Submittal Transmittal

IP&T Group - Tenant Build Out

Qty	Submittal Package No	Description	Due Date	Package Action
1	0015 - 08801 - 0	Glass Shop Drawings		Reviewed

Items	Description	Notes	Item Action
00002	Glass Shop Drawings & Data		Reviewed as Noted

3 EXTERIOR STOREFRONT FRAME TYPE SF-3 ELEVATION

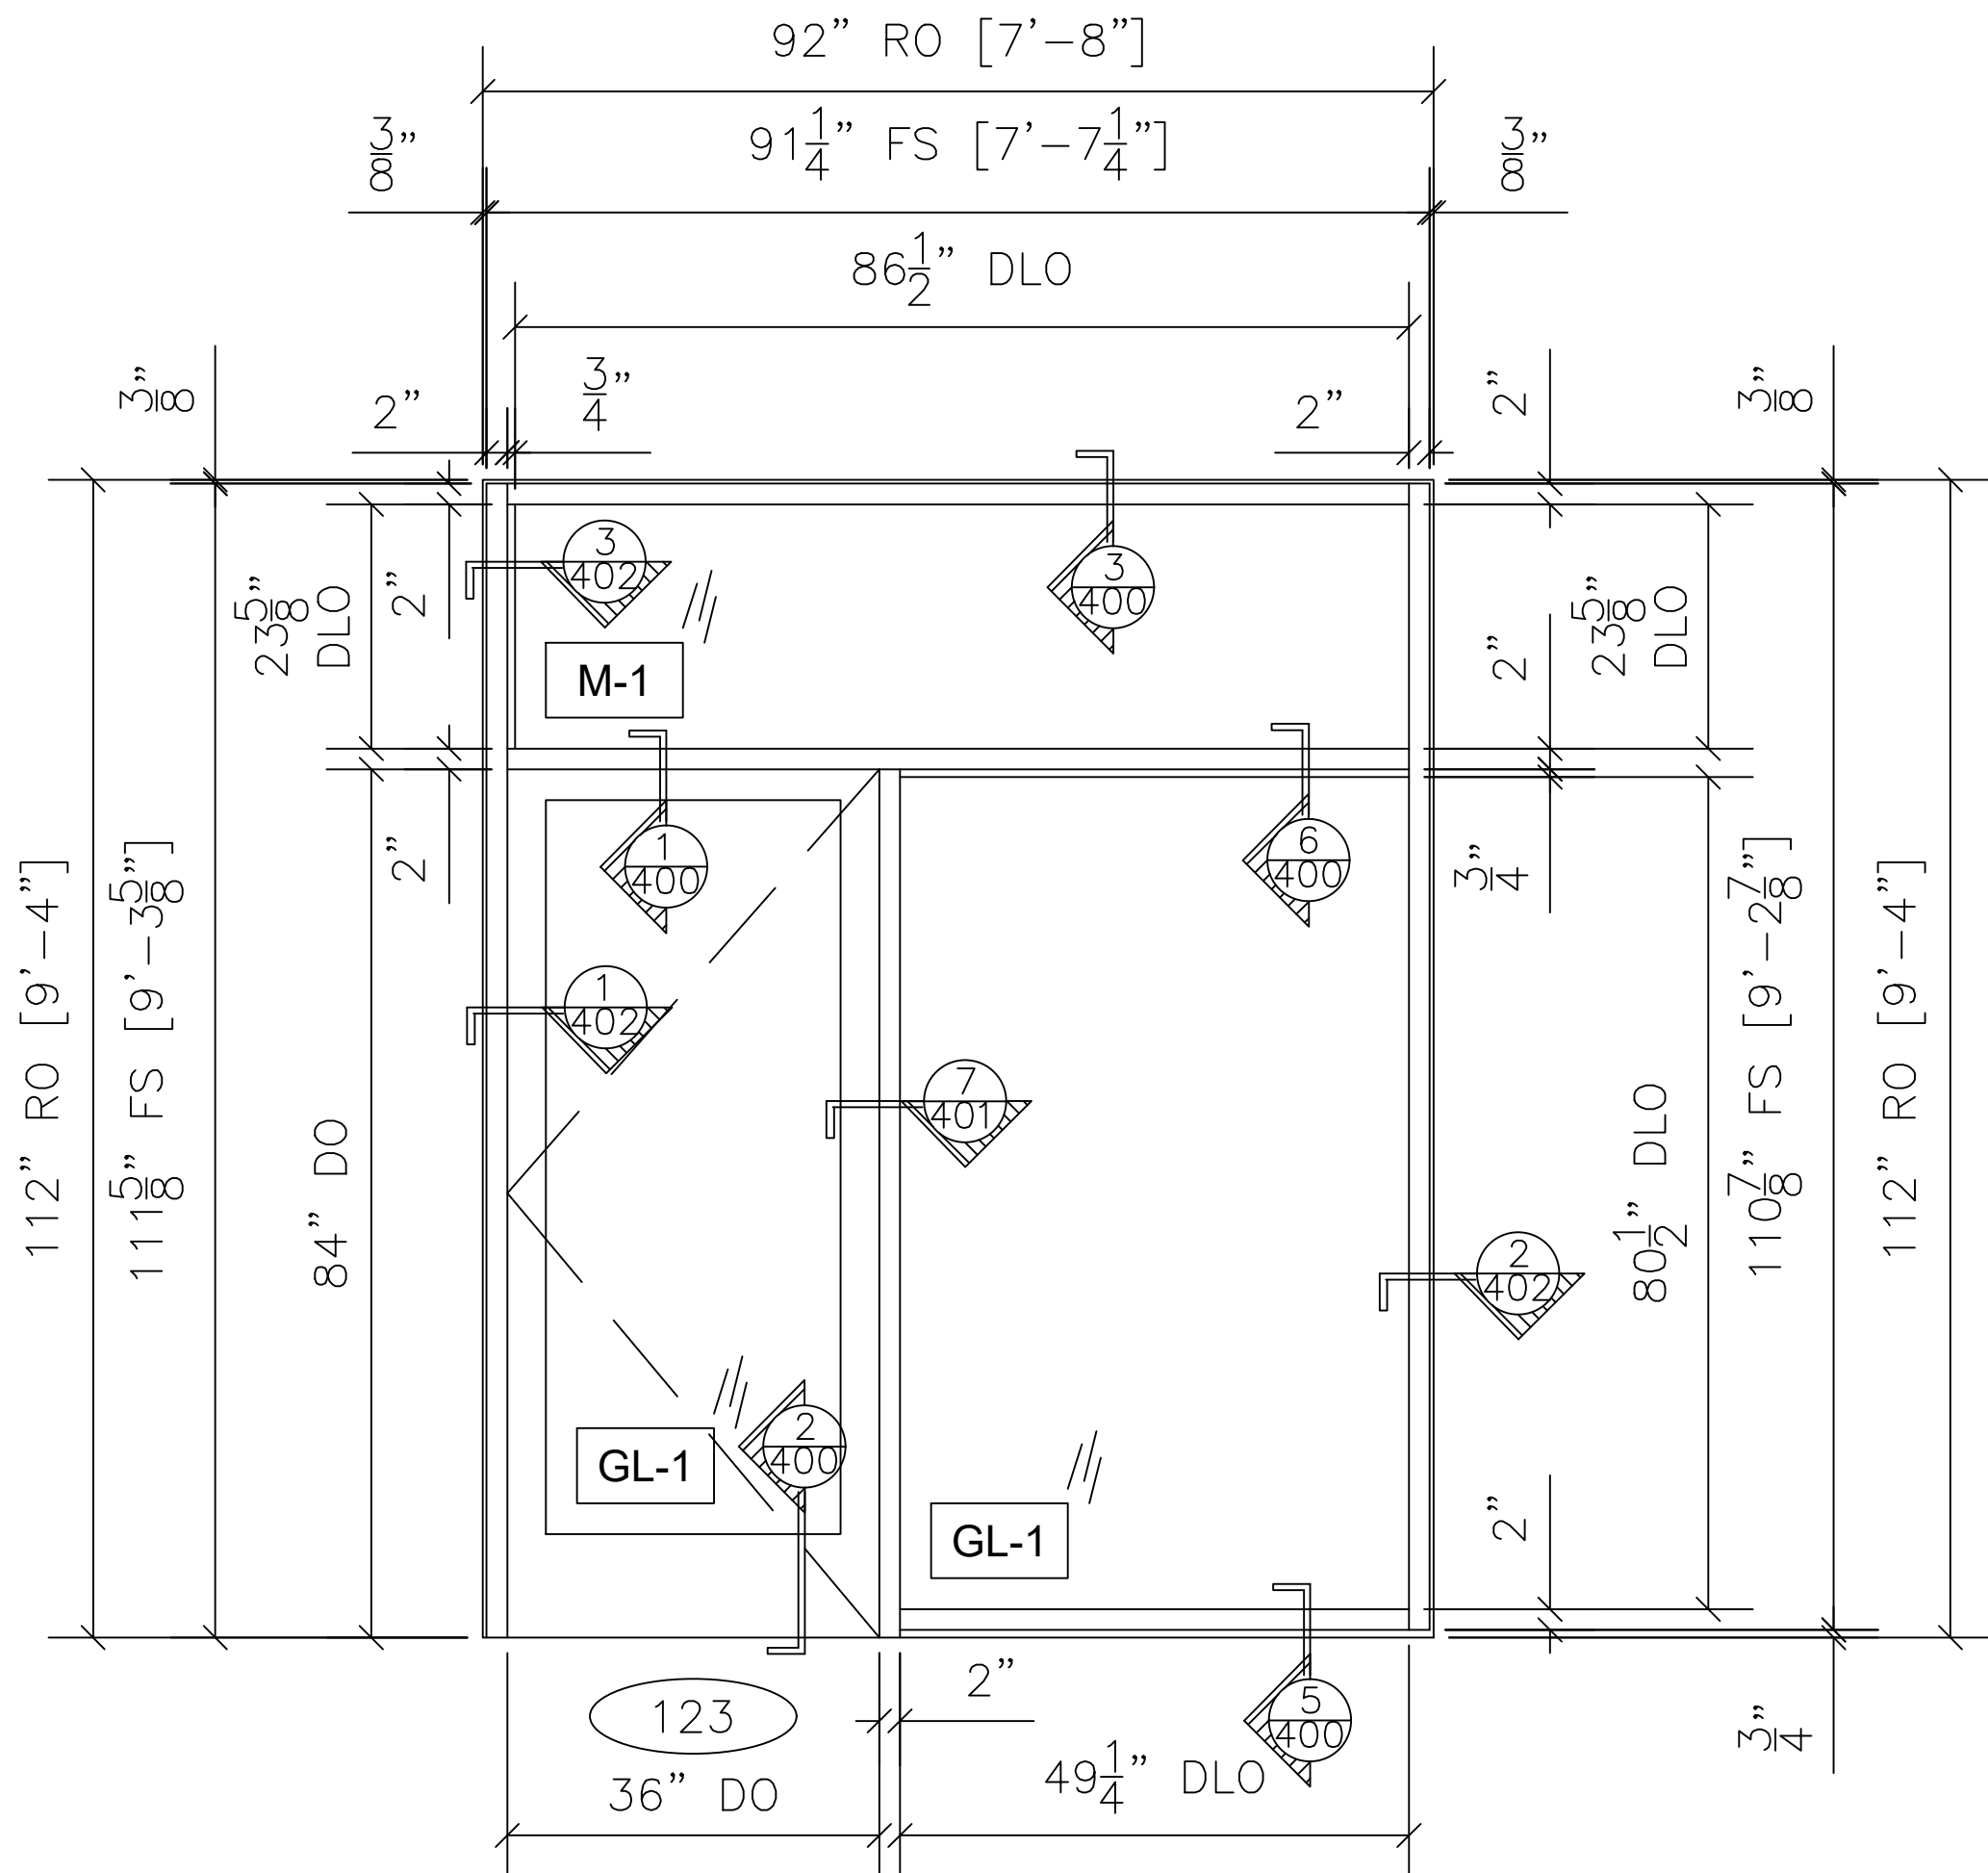
- 1.All Dimensions to be Verified by Nova Custom Glass in the field prior to release of materials (Majority are existing openings)
 - 2.Need to coordinate SF-3 Overall Height to Meet with the Ceiling Correctly.
 - 3.Color to be verified and Confirmed in field by Nova Custom Glass (New Store Front Material to Match Existing)
- Thank You
